Intelligence Community Campus – Bethesda (South Campus), Centrum

Preliminary approval of site and building plans

Approve with comments

Figure 12: East-west cross-section of Centrum.

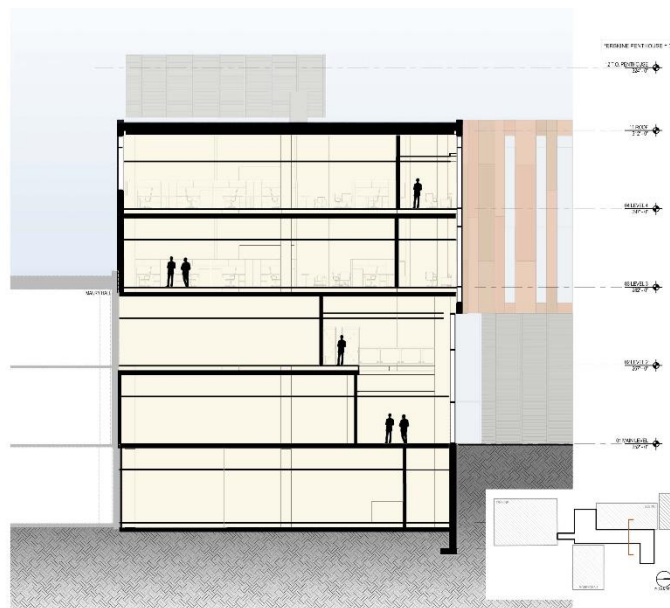
across the Potomac River at a point approximately 1.3 miles south near Chain Bridge, Erskine Hall is visible, and in particular the smoke stack and its mechanical penthouse. (Figure 13) Additional visual impacts from the Centrum are not expected since its overall height is lower than Erskine Hall and will largely be blocked by Erskine Hall from this vantage point. Visual impacts to the C&O Canal National Historic Park and the Clara Barton Parkway are also not expected due to the Centrum's distance from the west property line and the existence of Maury Hall, existing

Figure 14: East and west elevations of the Centrum

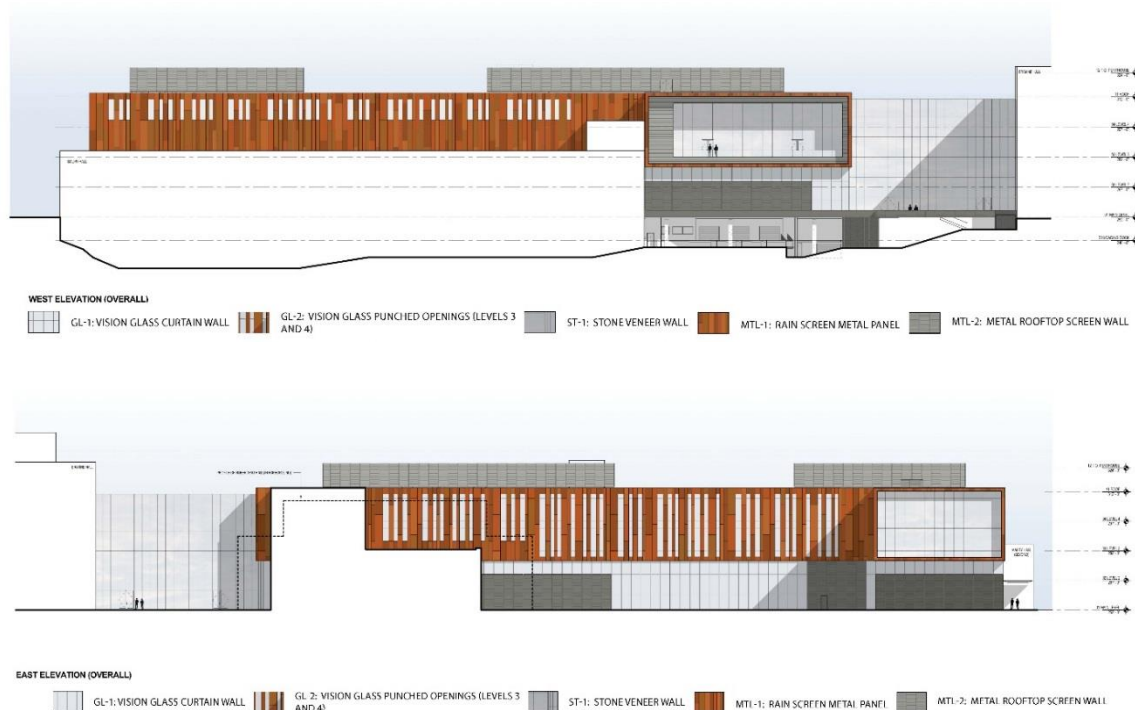
tree canopy, and the difference in elevation. If there is any portion of the Centrum that may create a visual impact it would be the rooftop penthouses. As proposed, the penthouses have a height of 12 feet, which is lower than other penthouses that staff has seen in other building projects. For comparison purposes, staff consulted the Montgomery County Zoning Ordinance which does not appear to regulate the maximum height of mechanical penthouses. Though not applicable, staff notes that in the District of Columbia, an area where mechanical penthouse are closely regulated, the maximum permissible height is set at 18 feet 6 inches. While the height of the proposed penthouses is consistent, their lengths vary with the longest being approximately 90 feet. While staff recognizes that there are mechanical, structural, and functional requirements associated with the design and location of these building features, it also has seen instances where the visual presence of these features has been further minimized by breaking up penthouse enclosures and/or relocating equipment to an adjacent roof level. Therefore, while the proposal does not present any significant visual issues associated with the mechanical penthouses, staff recommends that the applicant **evaluate whether any reductions in the penthouse height and massing can be made, and to evaluate setting back the penthouses from all exterior walls a distance greater than or equal to their height** in order to further minimize any potential views of the penthouses from the west, and strengthen the architectural presence of the Centrum when viewed from the east. (Figure 14)

- Reduce the height and mass of the Centrum penthouse enclosures, and setback penthouses from all exterior walls a distance greater than or equal to their height.
- Expand the area of the green roof and design the system to the greatest depth possible.
- Take into consideration the total estimated South Campus rooftop runoff volume and anticipated building greywater need when determining the final storage capacity of the cistern.
- Expand the capacity of the micro-bioretenion areas by designing them to store the highest rainfall target technically feasible.

Figure 19: Massing diagram of relation between South Campus and existing development.

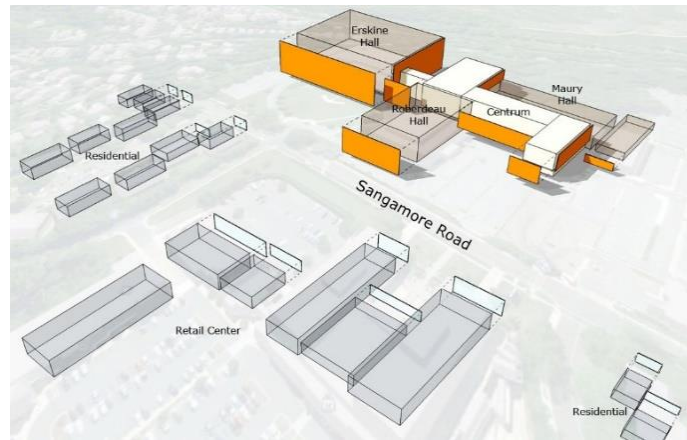
Programmatically, the proposed Centrum is consistent with what is contemplated in the ICC-B Master Plan, the current proposal maintains the same points of employee and visitor arrival as well as amenities such as the auditorium, amenity spaces, cafeteria, and building support spaces. The overall height, mass, bulk, organization, orientation, and exterior materials of the current proposal are also consistent with what is contemplated in the ICC-B Master Plan, although further refined. As currently designed, the Centrum will appear less massive, and therefore less visually intrusive on the site and neighborhood, compared to what is presented in the Master Plan. Rather than designing the Centrum to create the sense of one building mass, the current proposal maintains the massing of the existing buildings, responds to the development pattern across Sangamore Road, and allows the Centrum to have its own identity. (Figure 19)
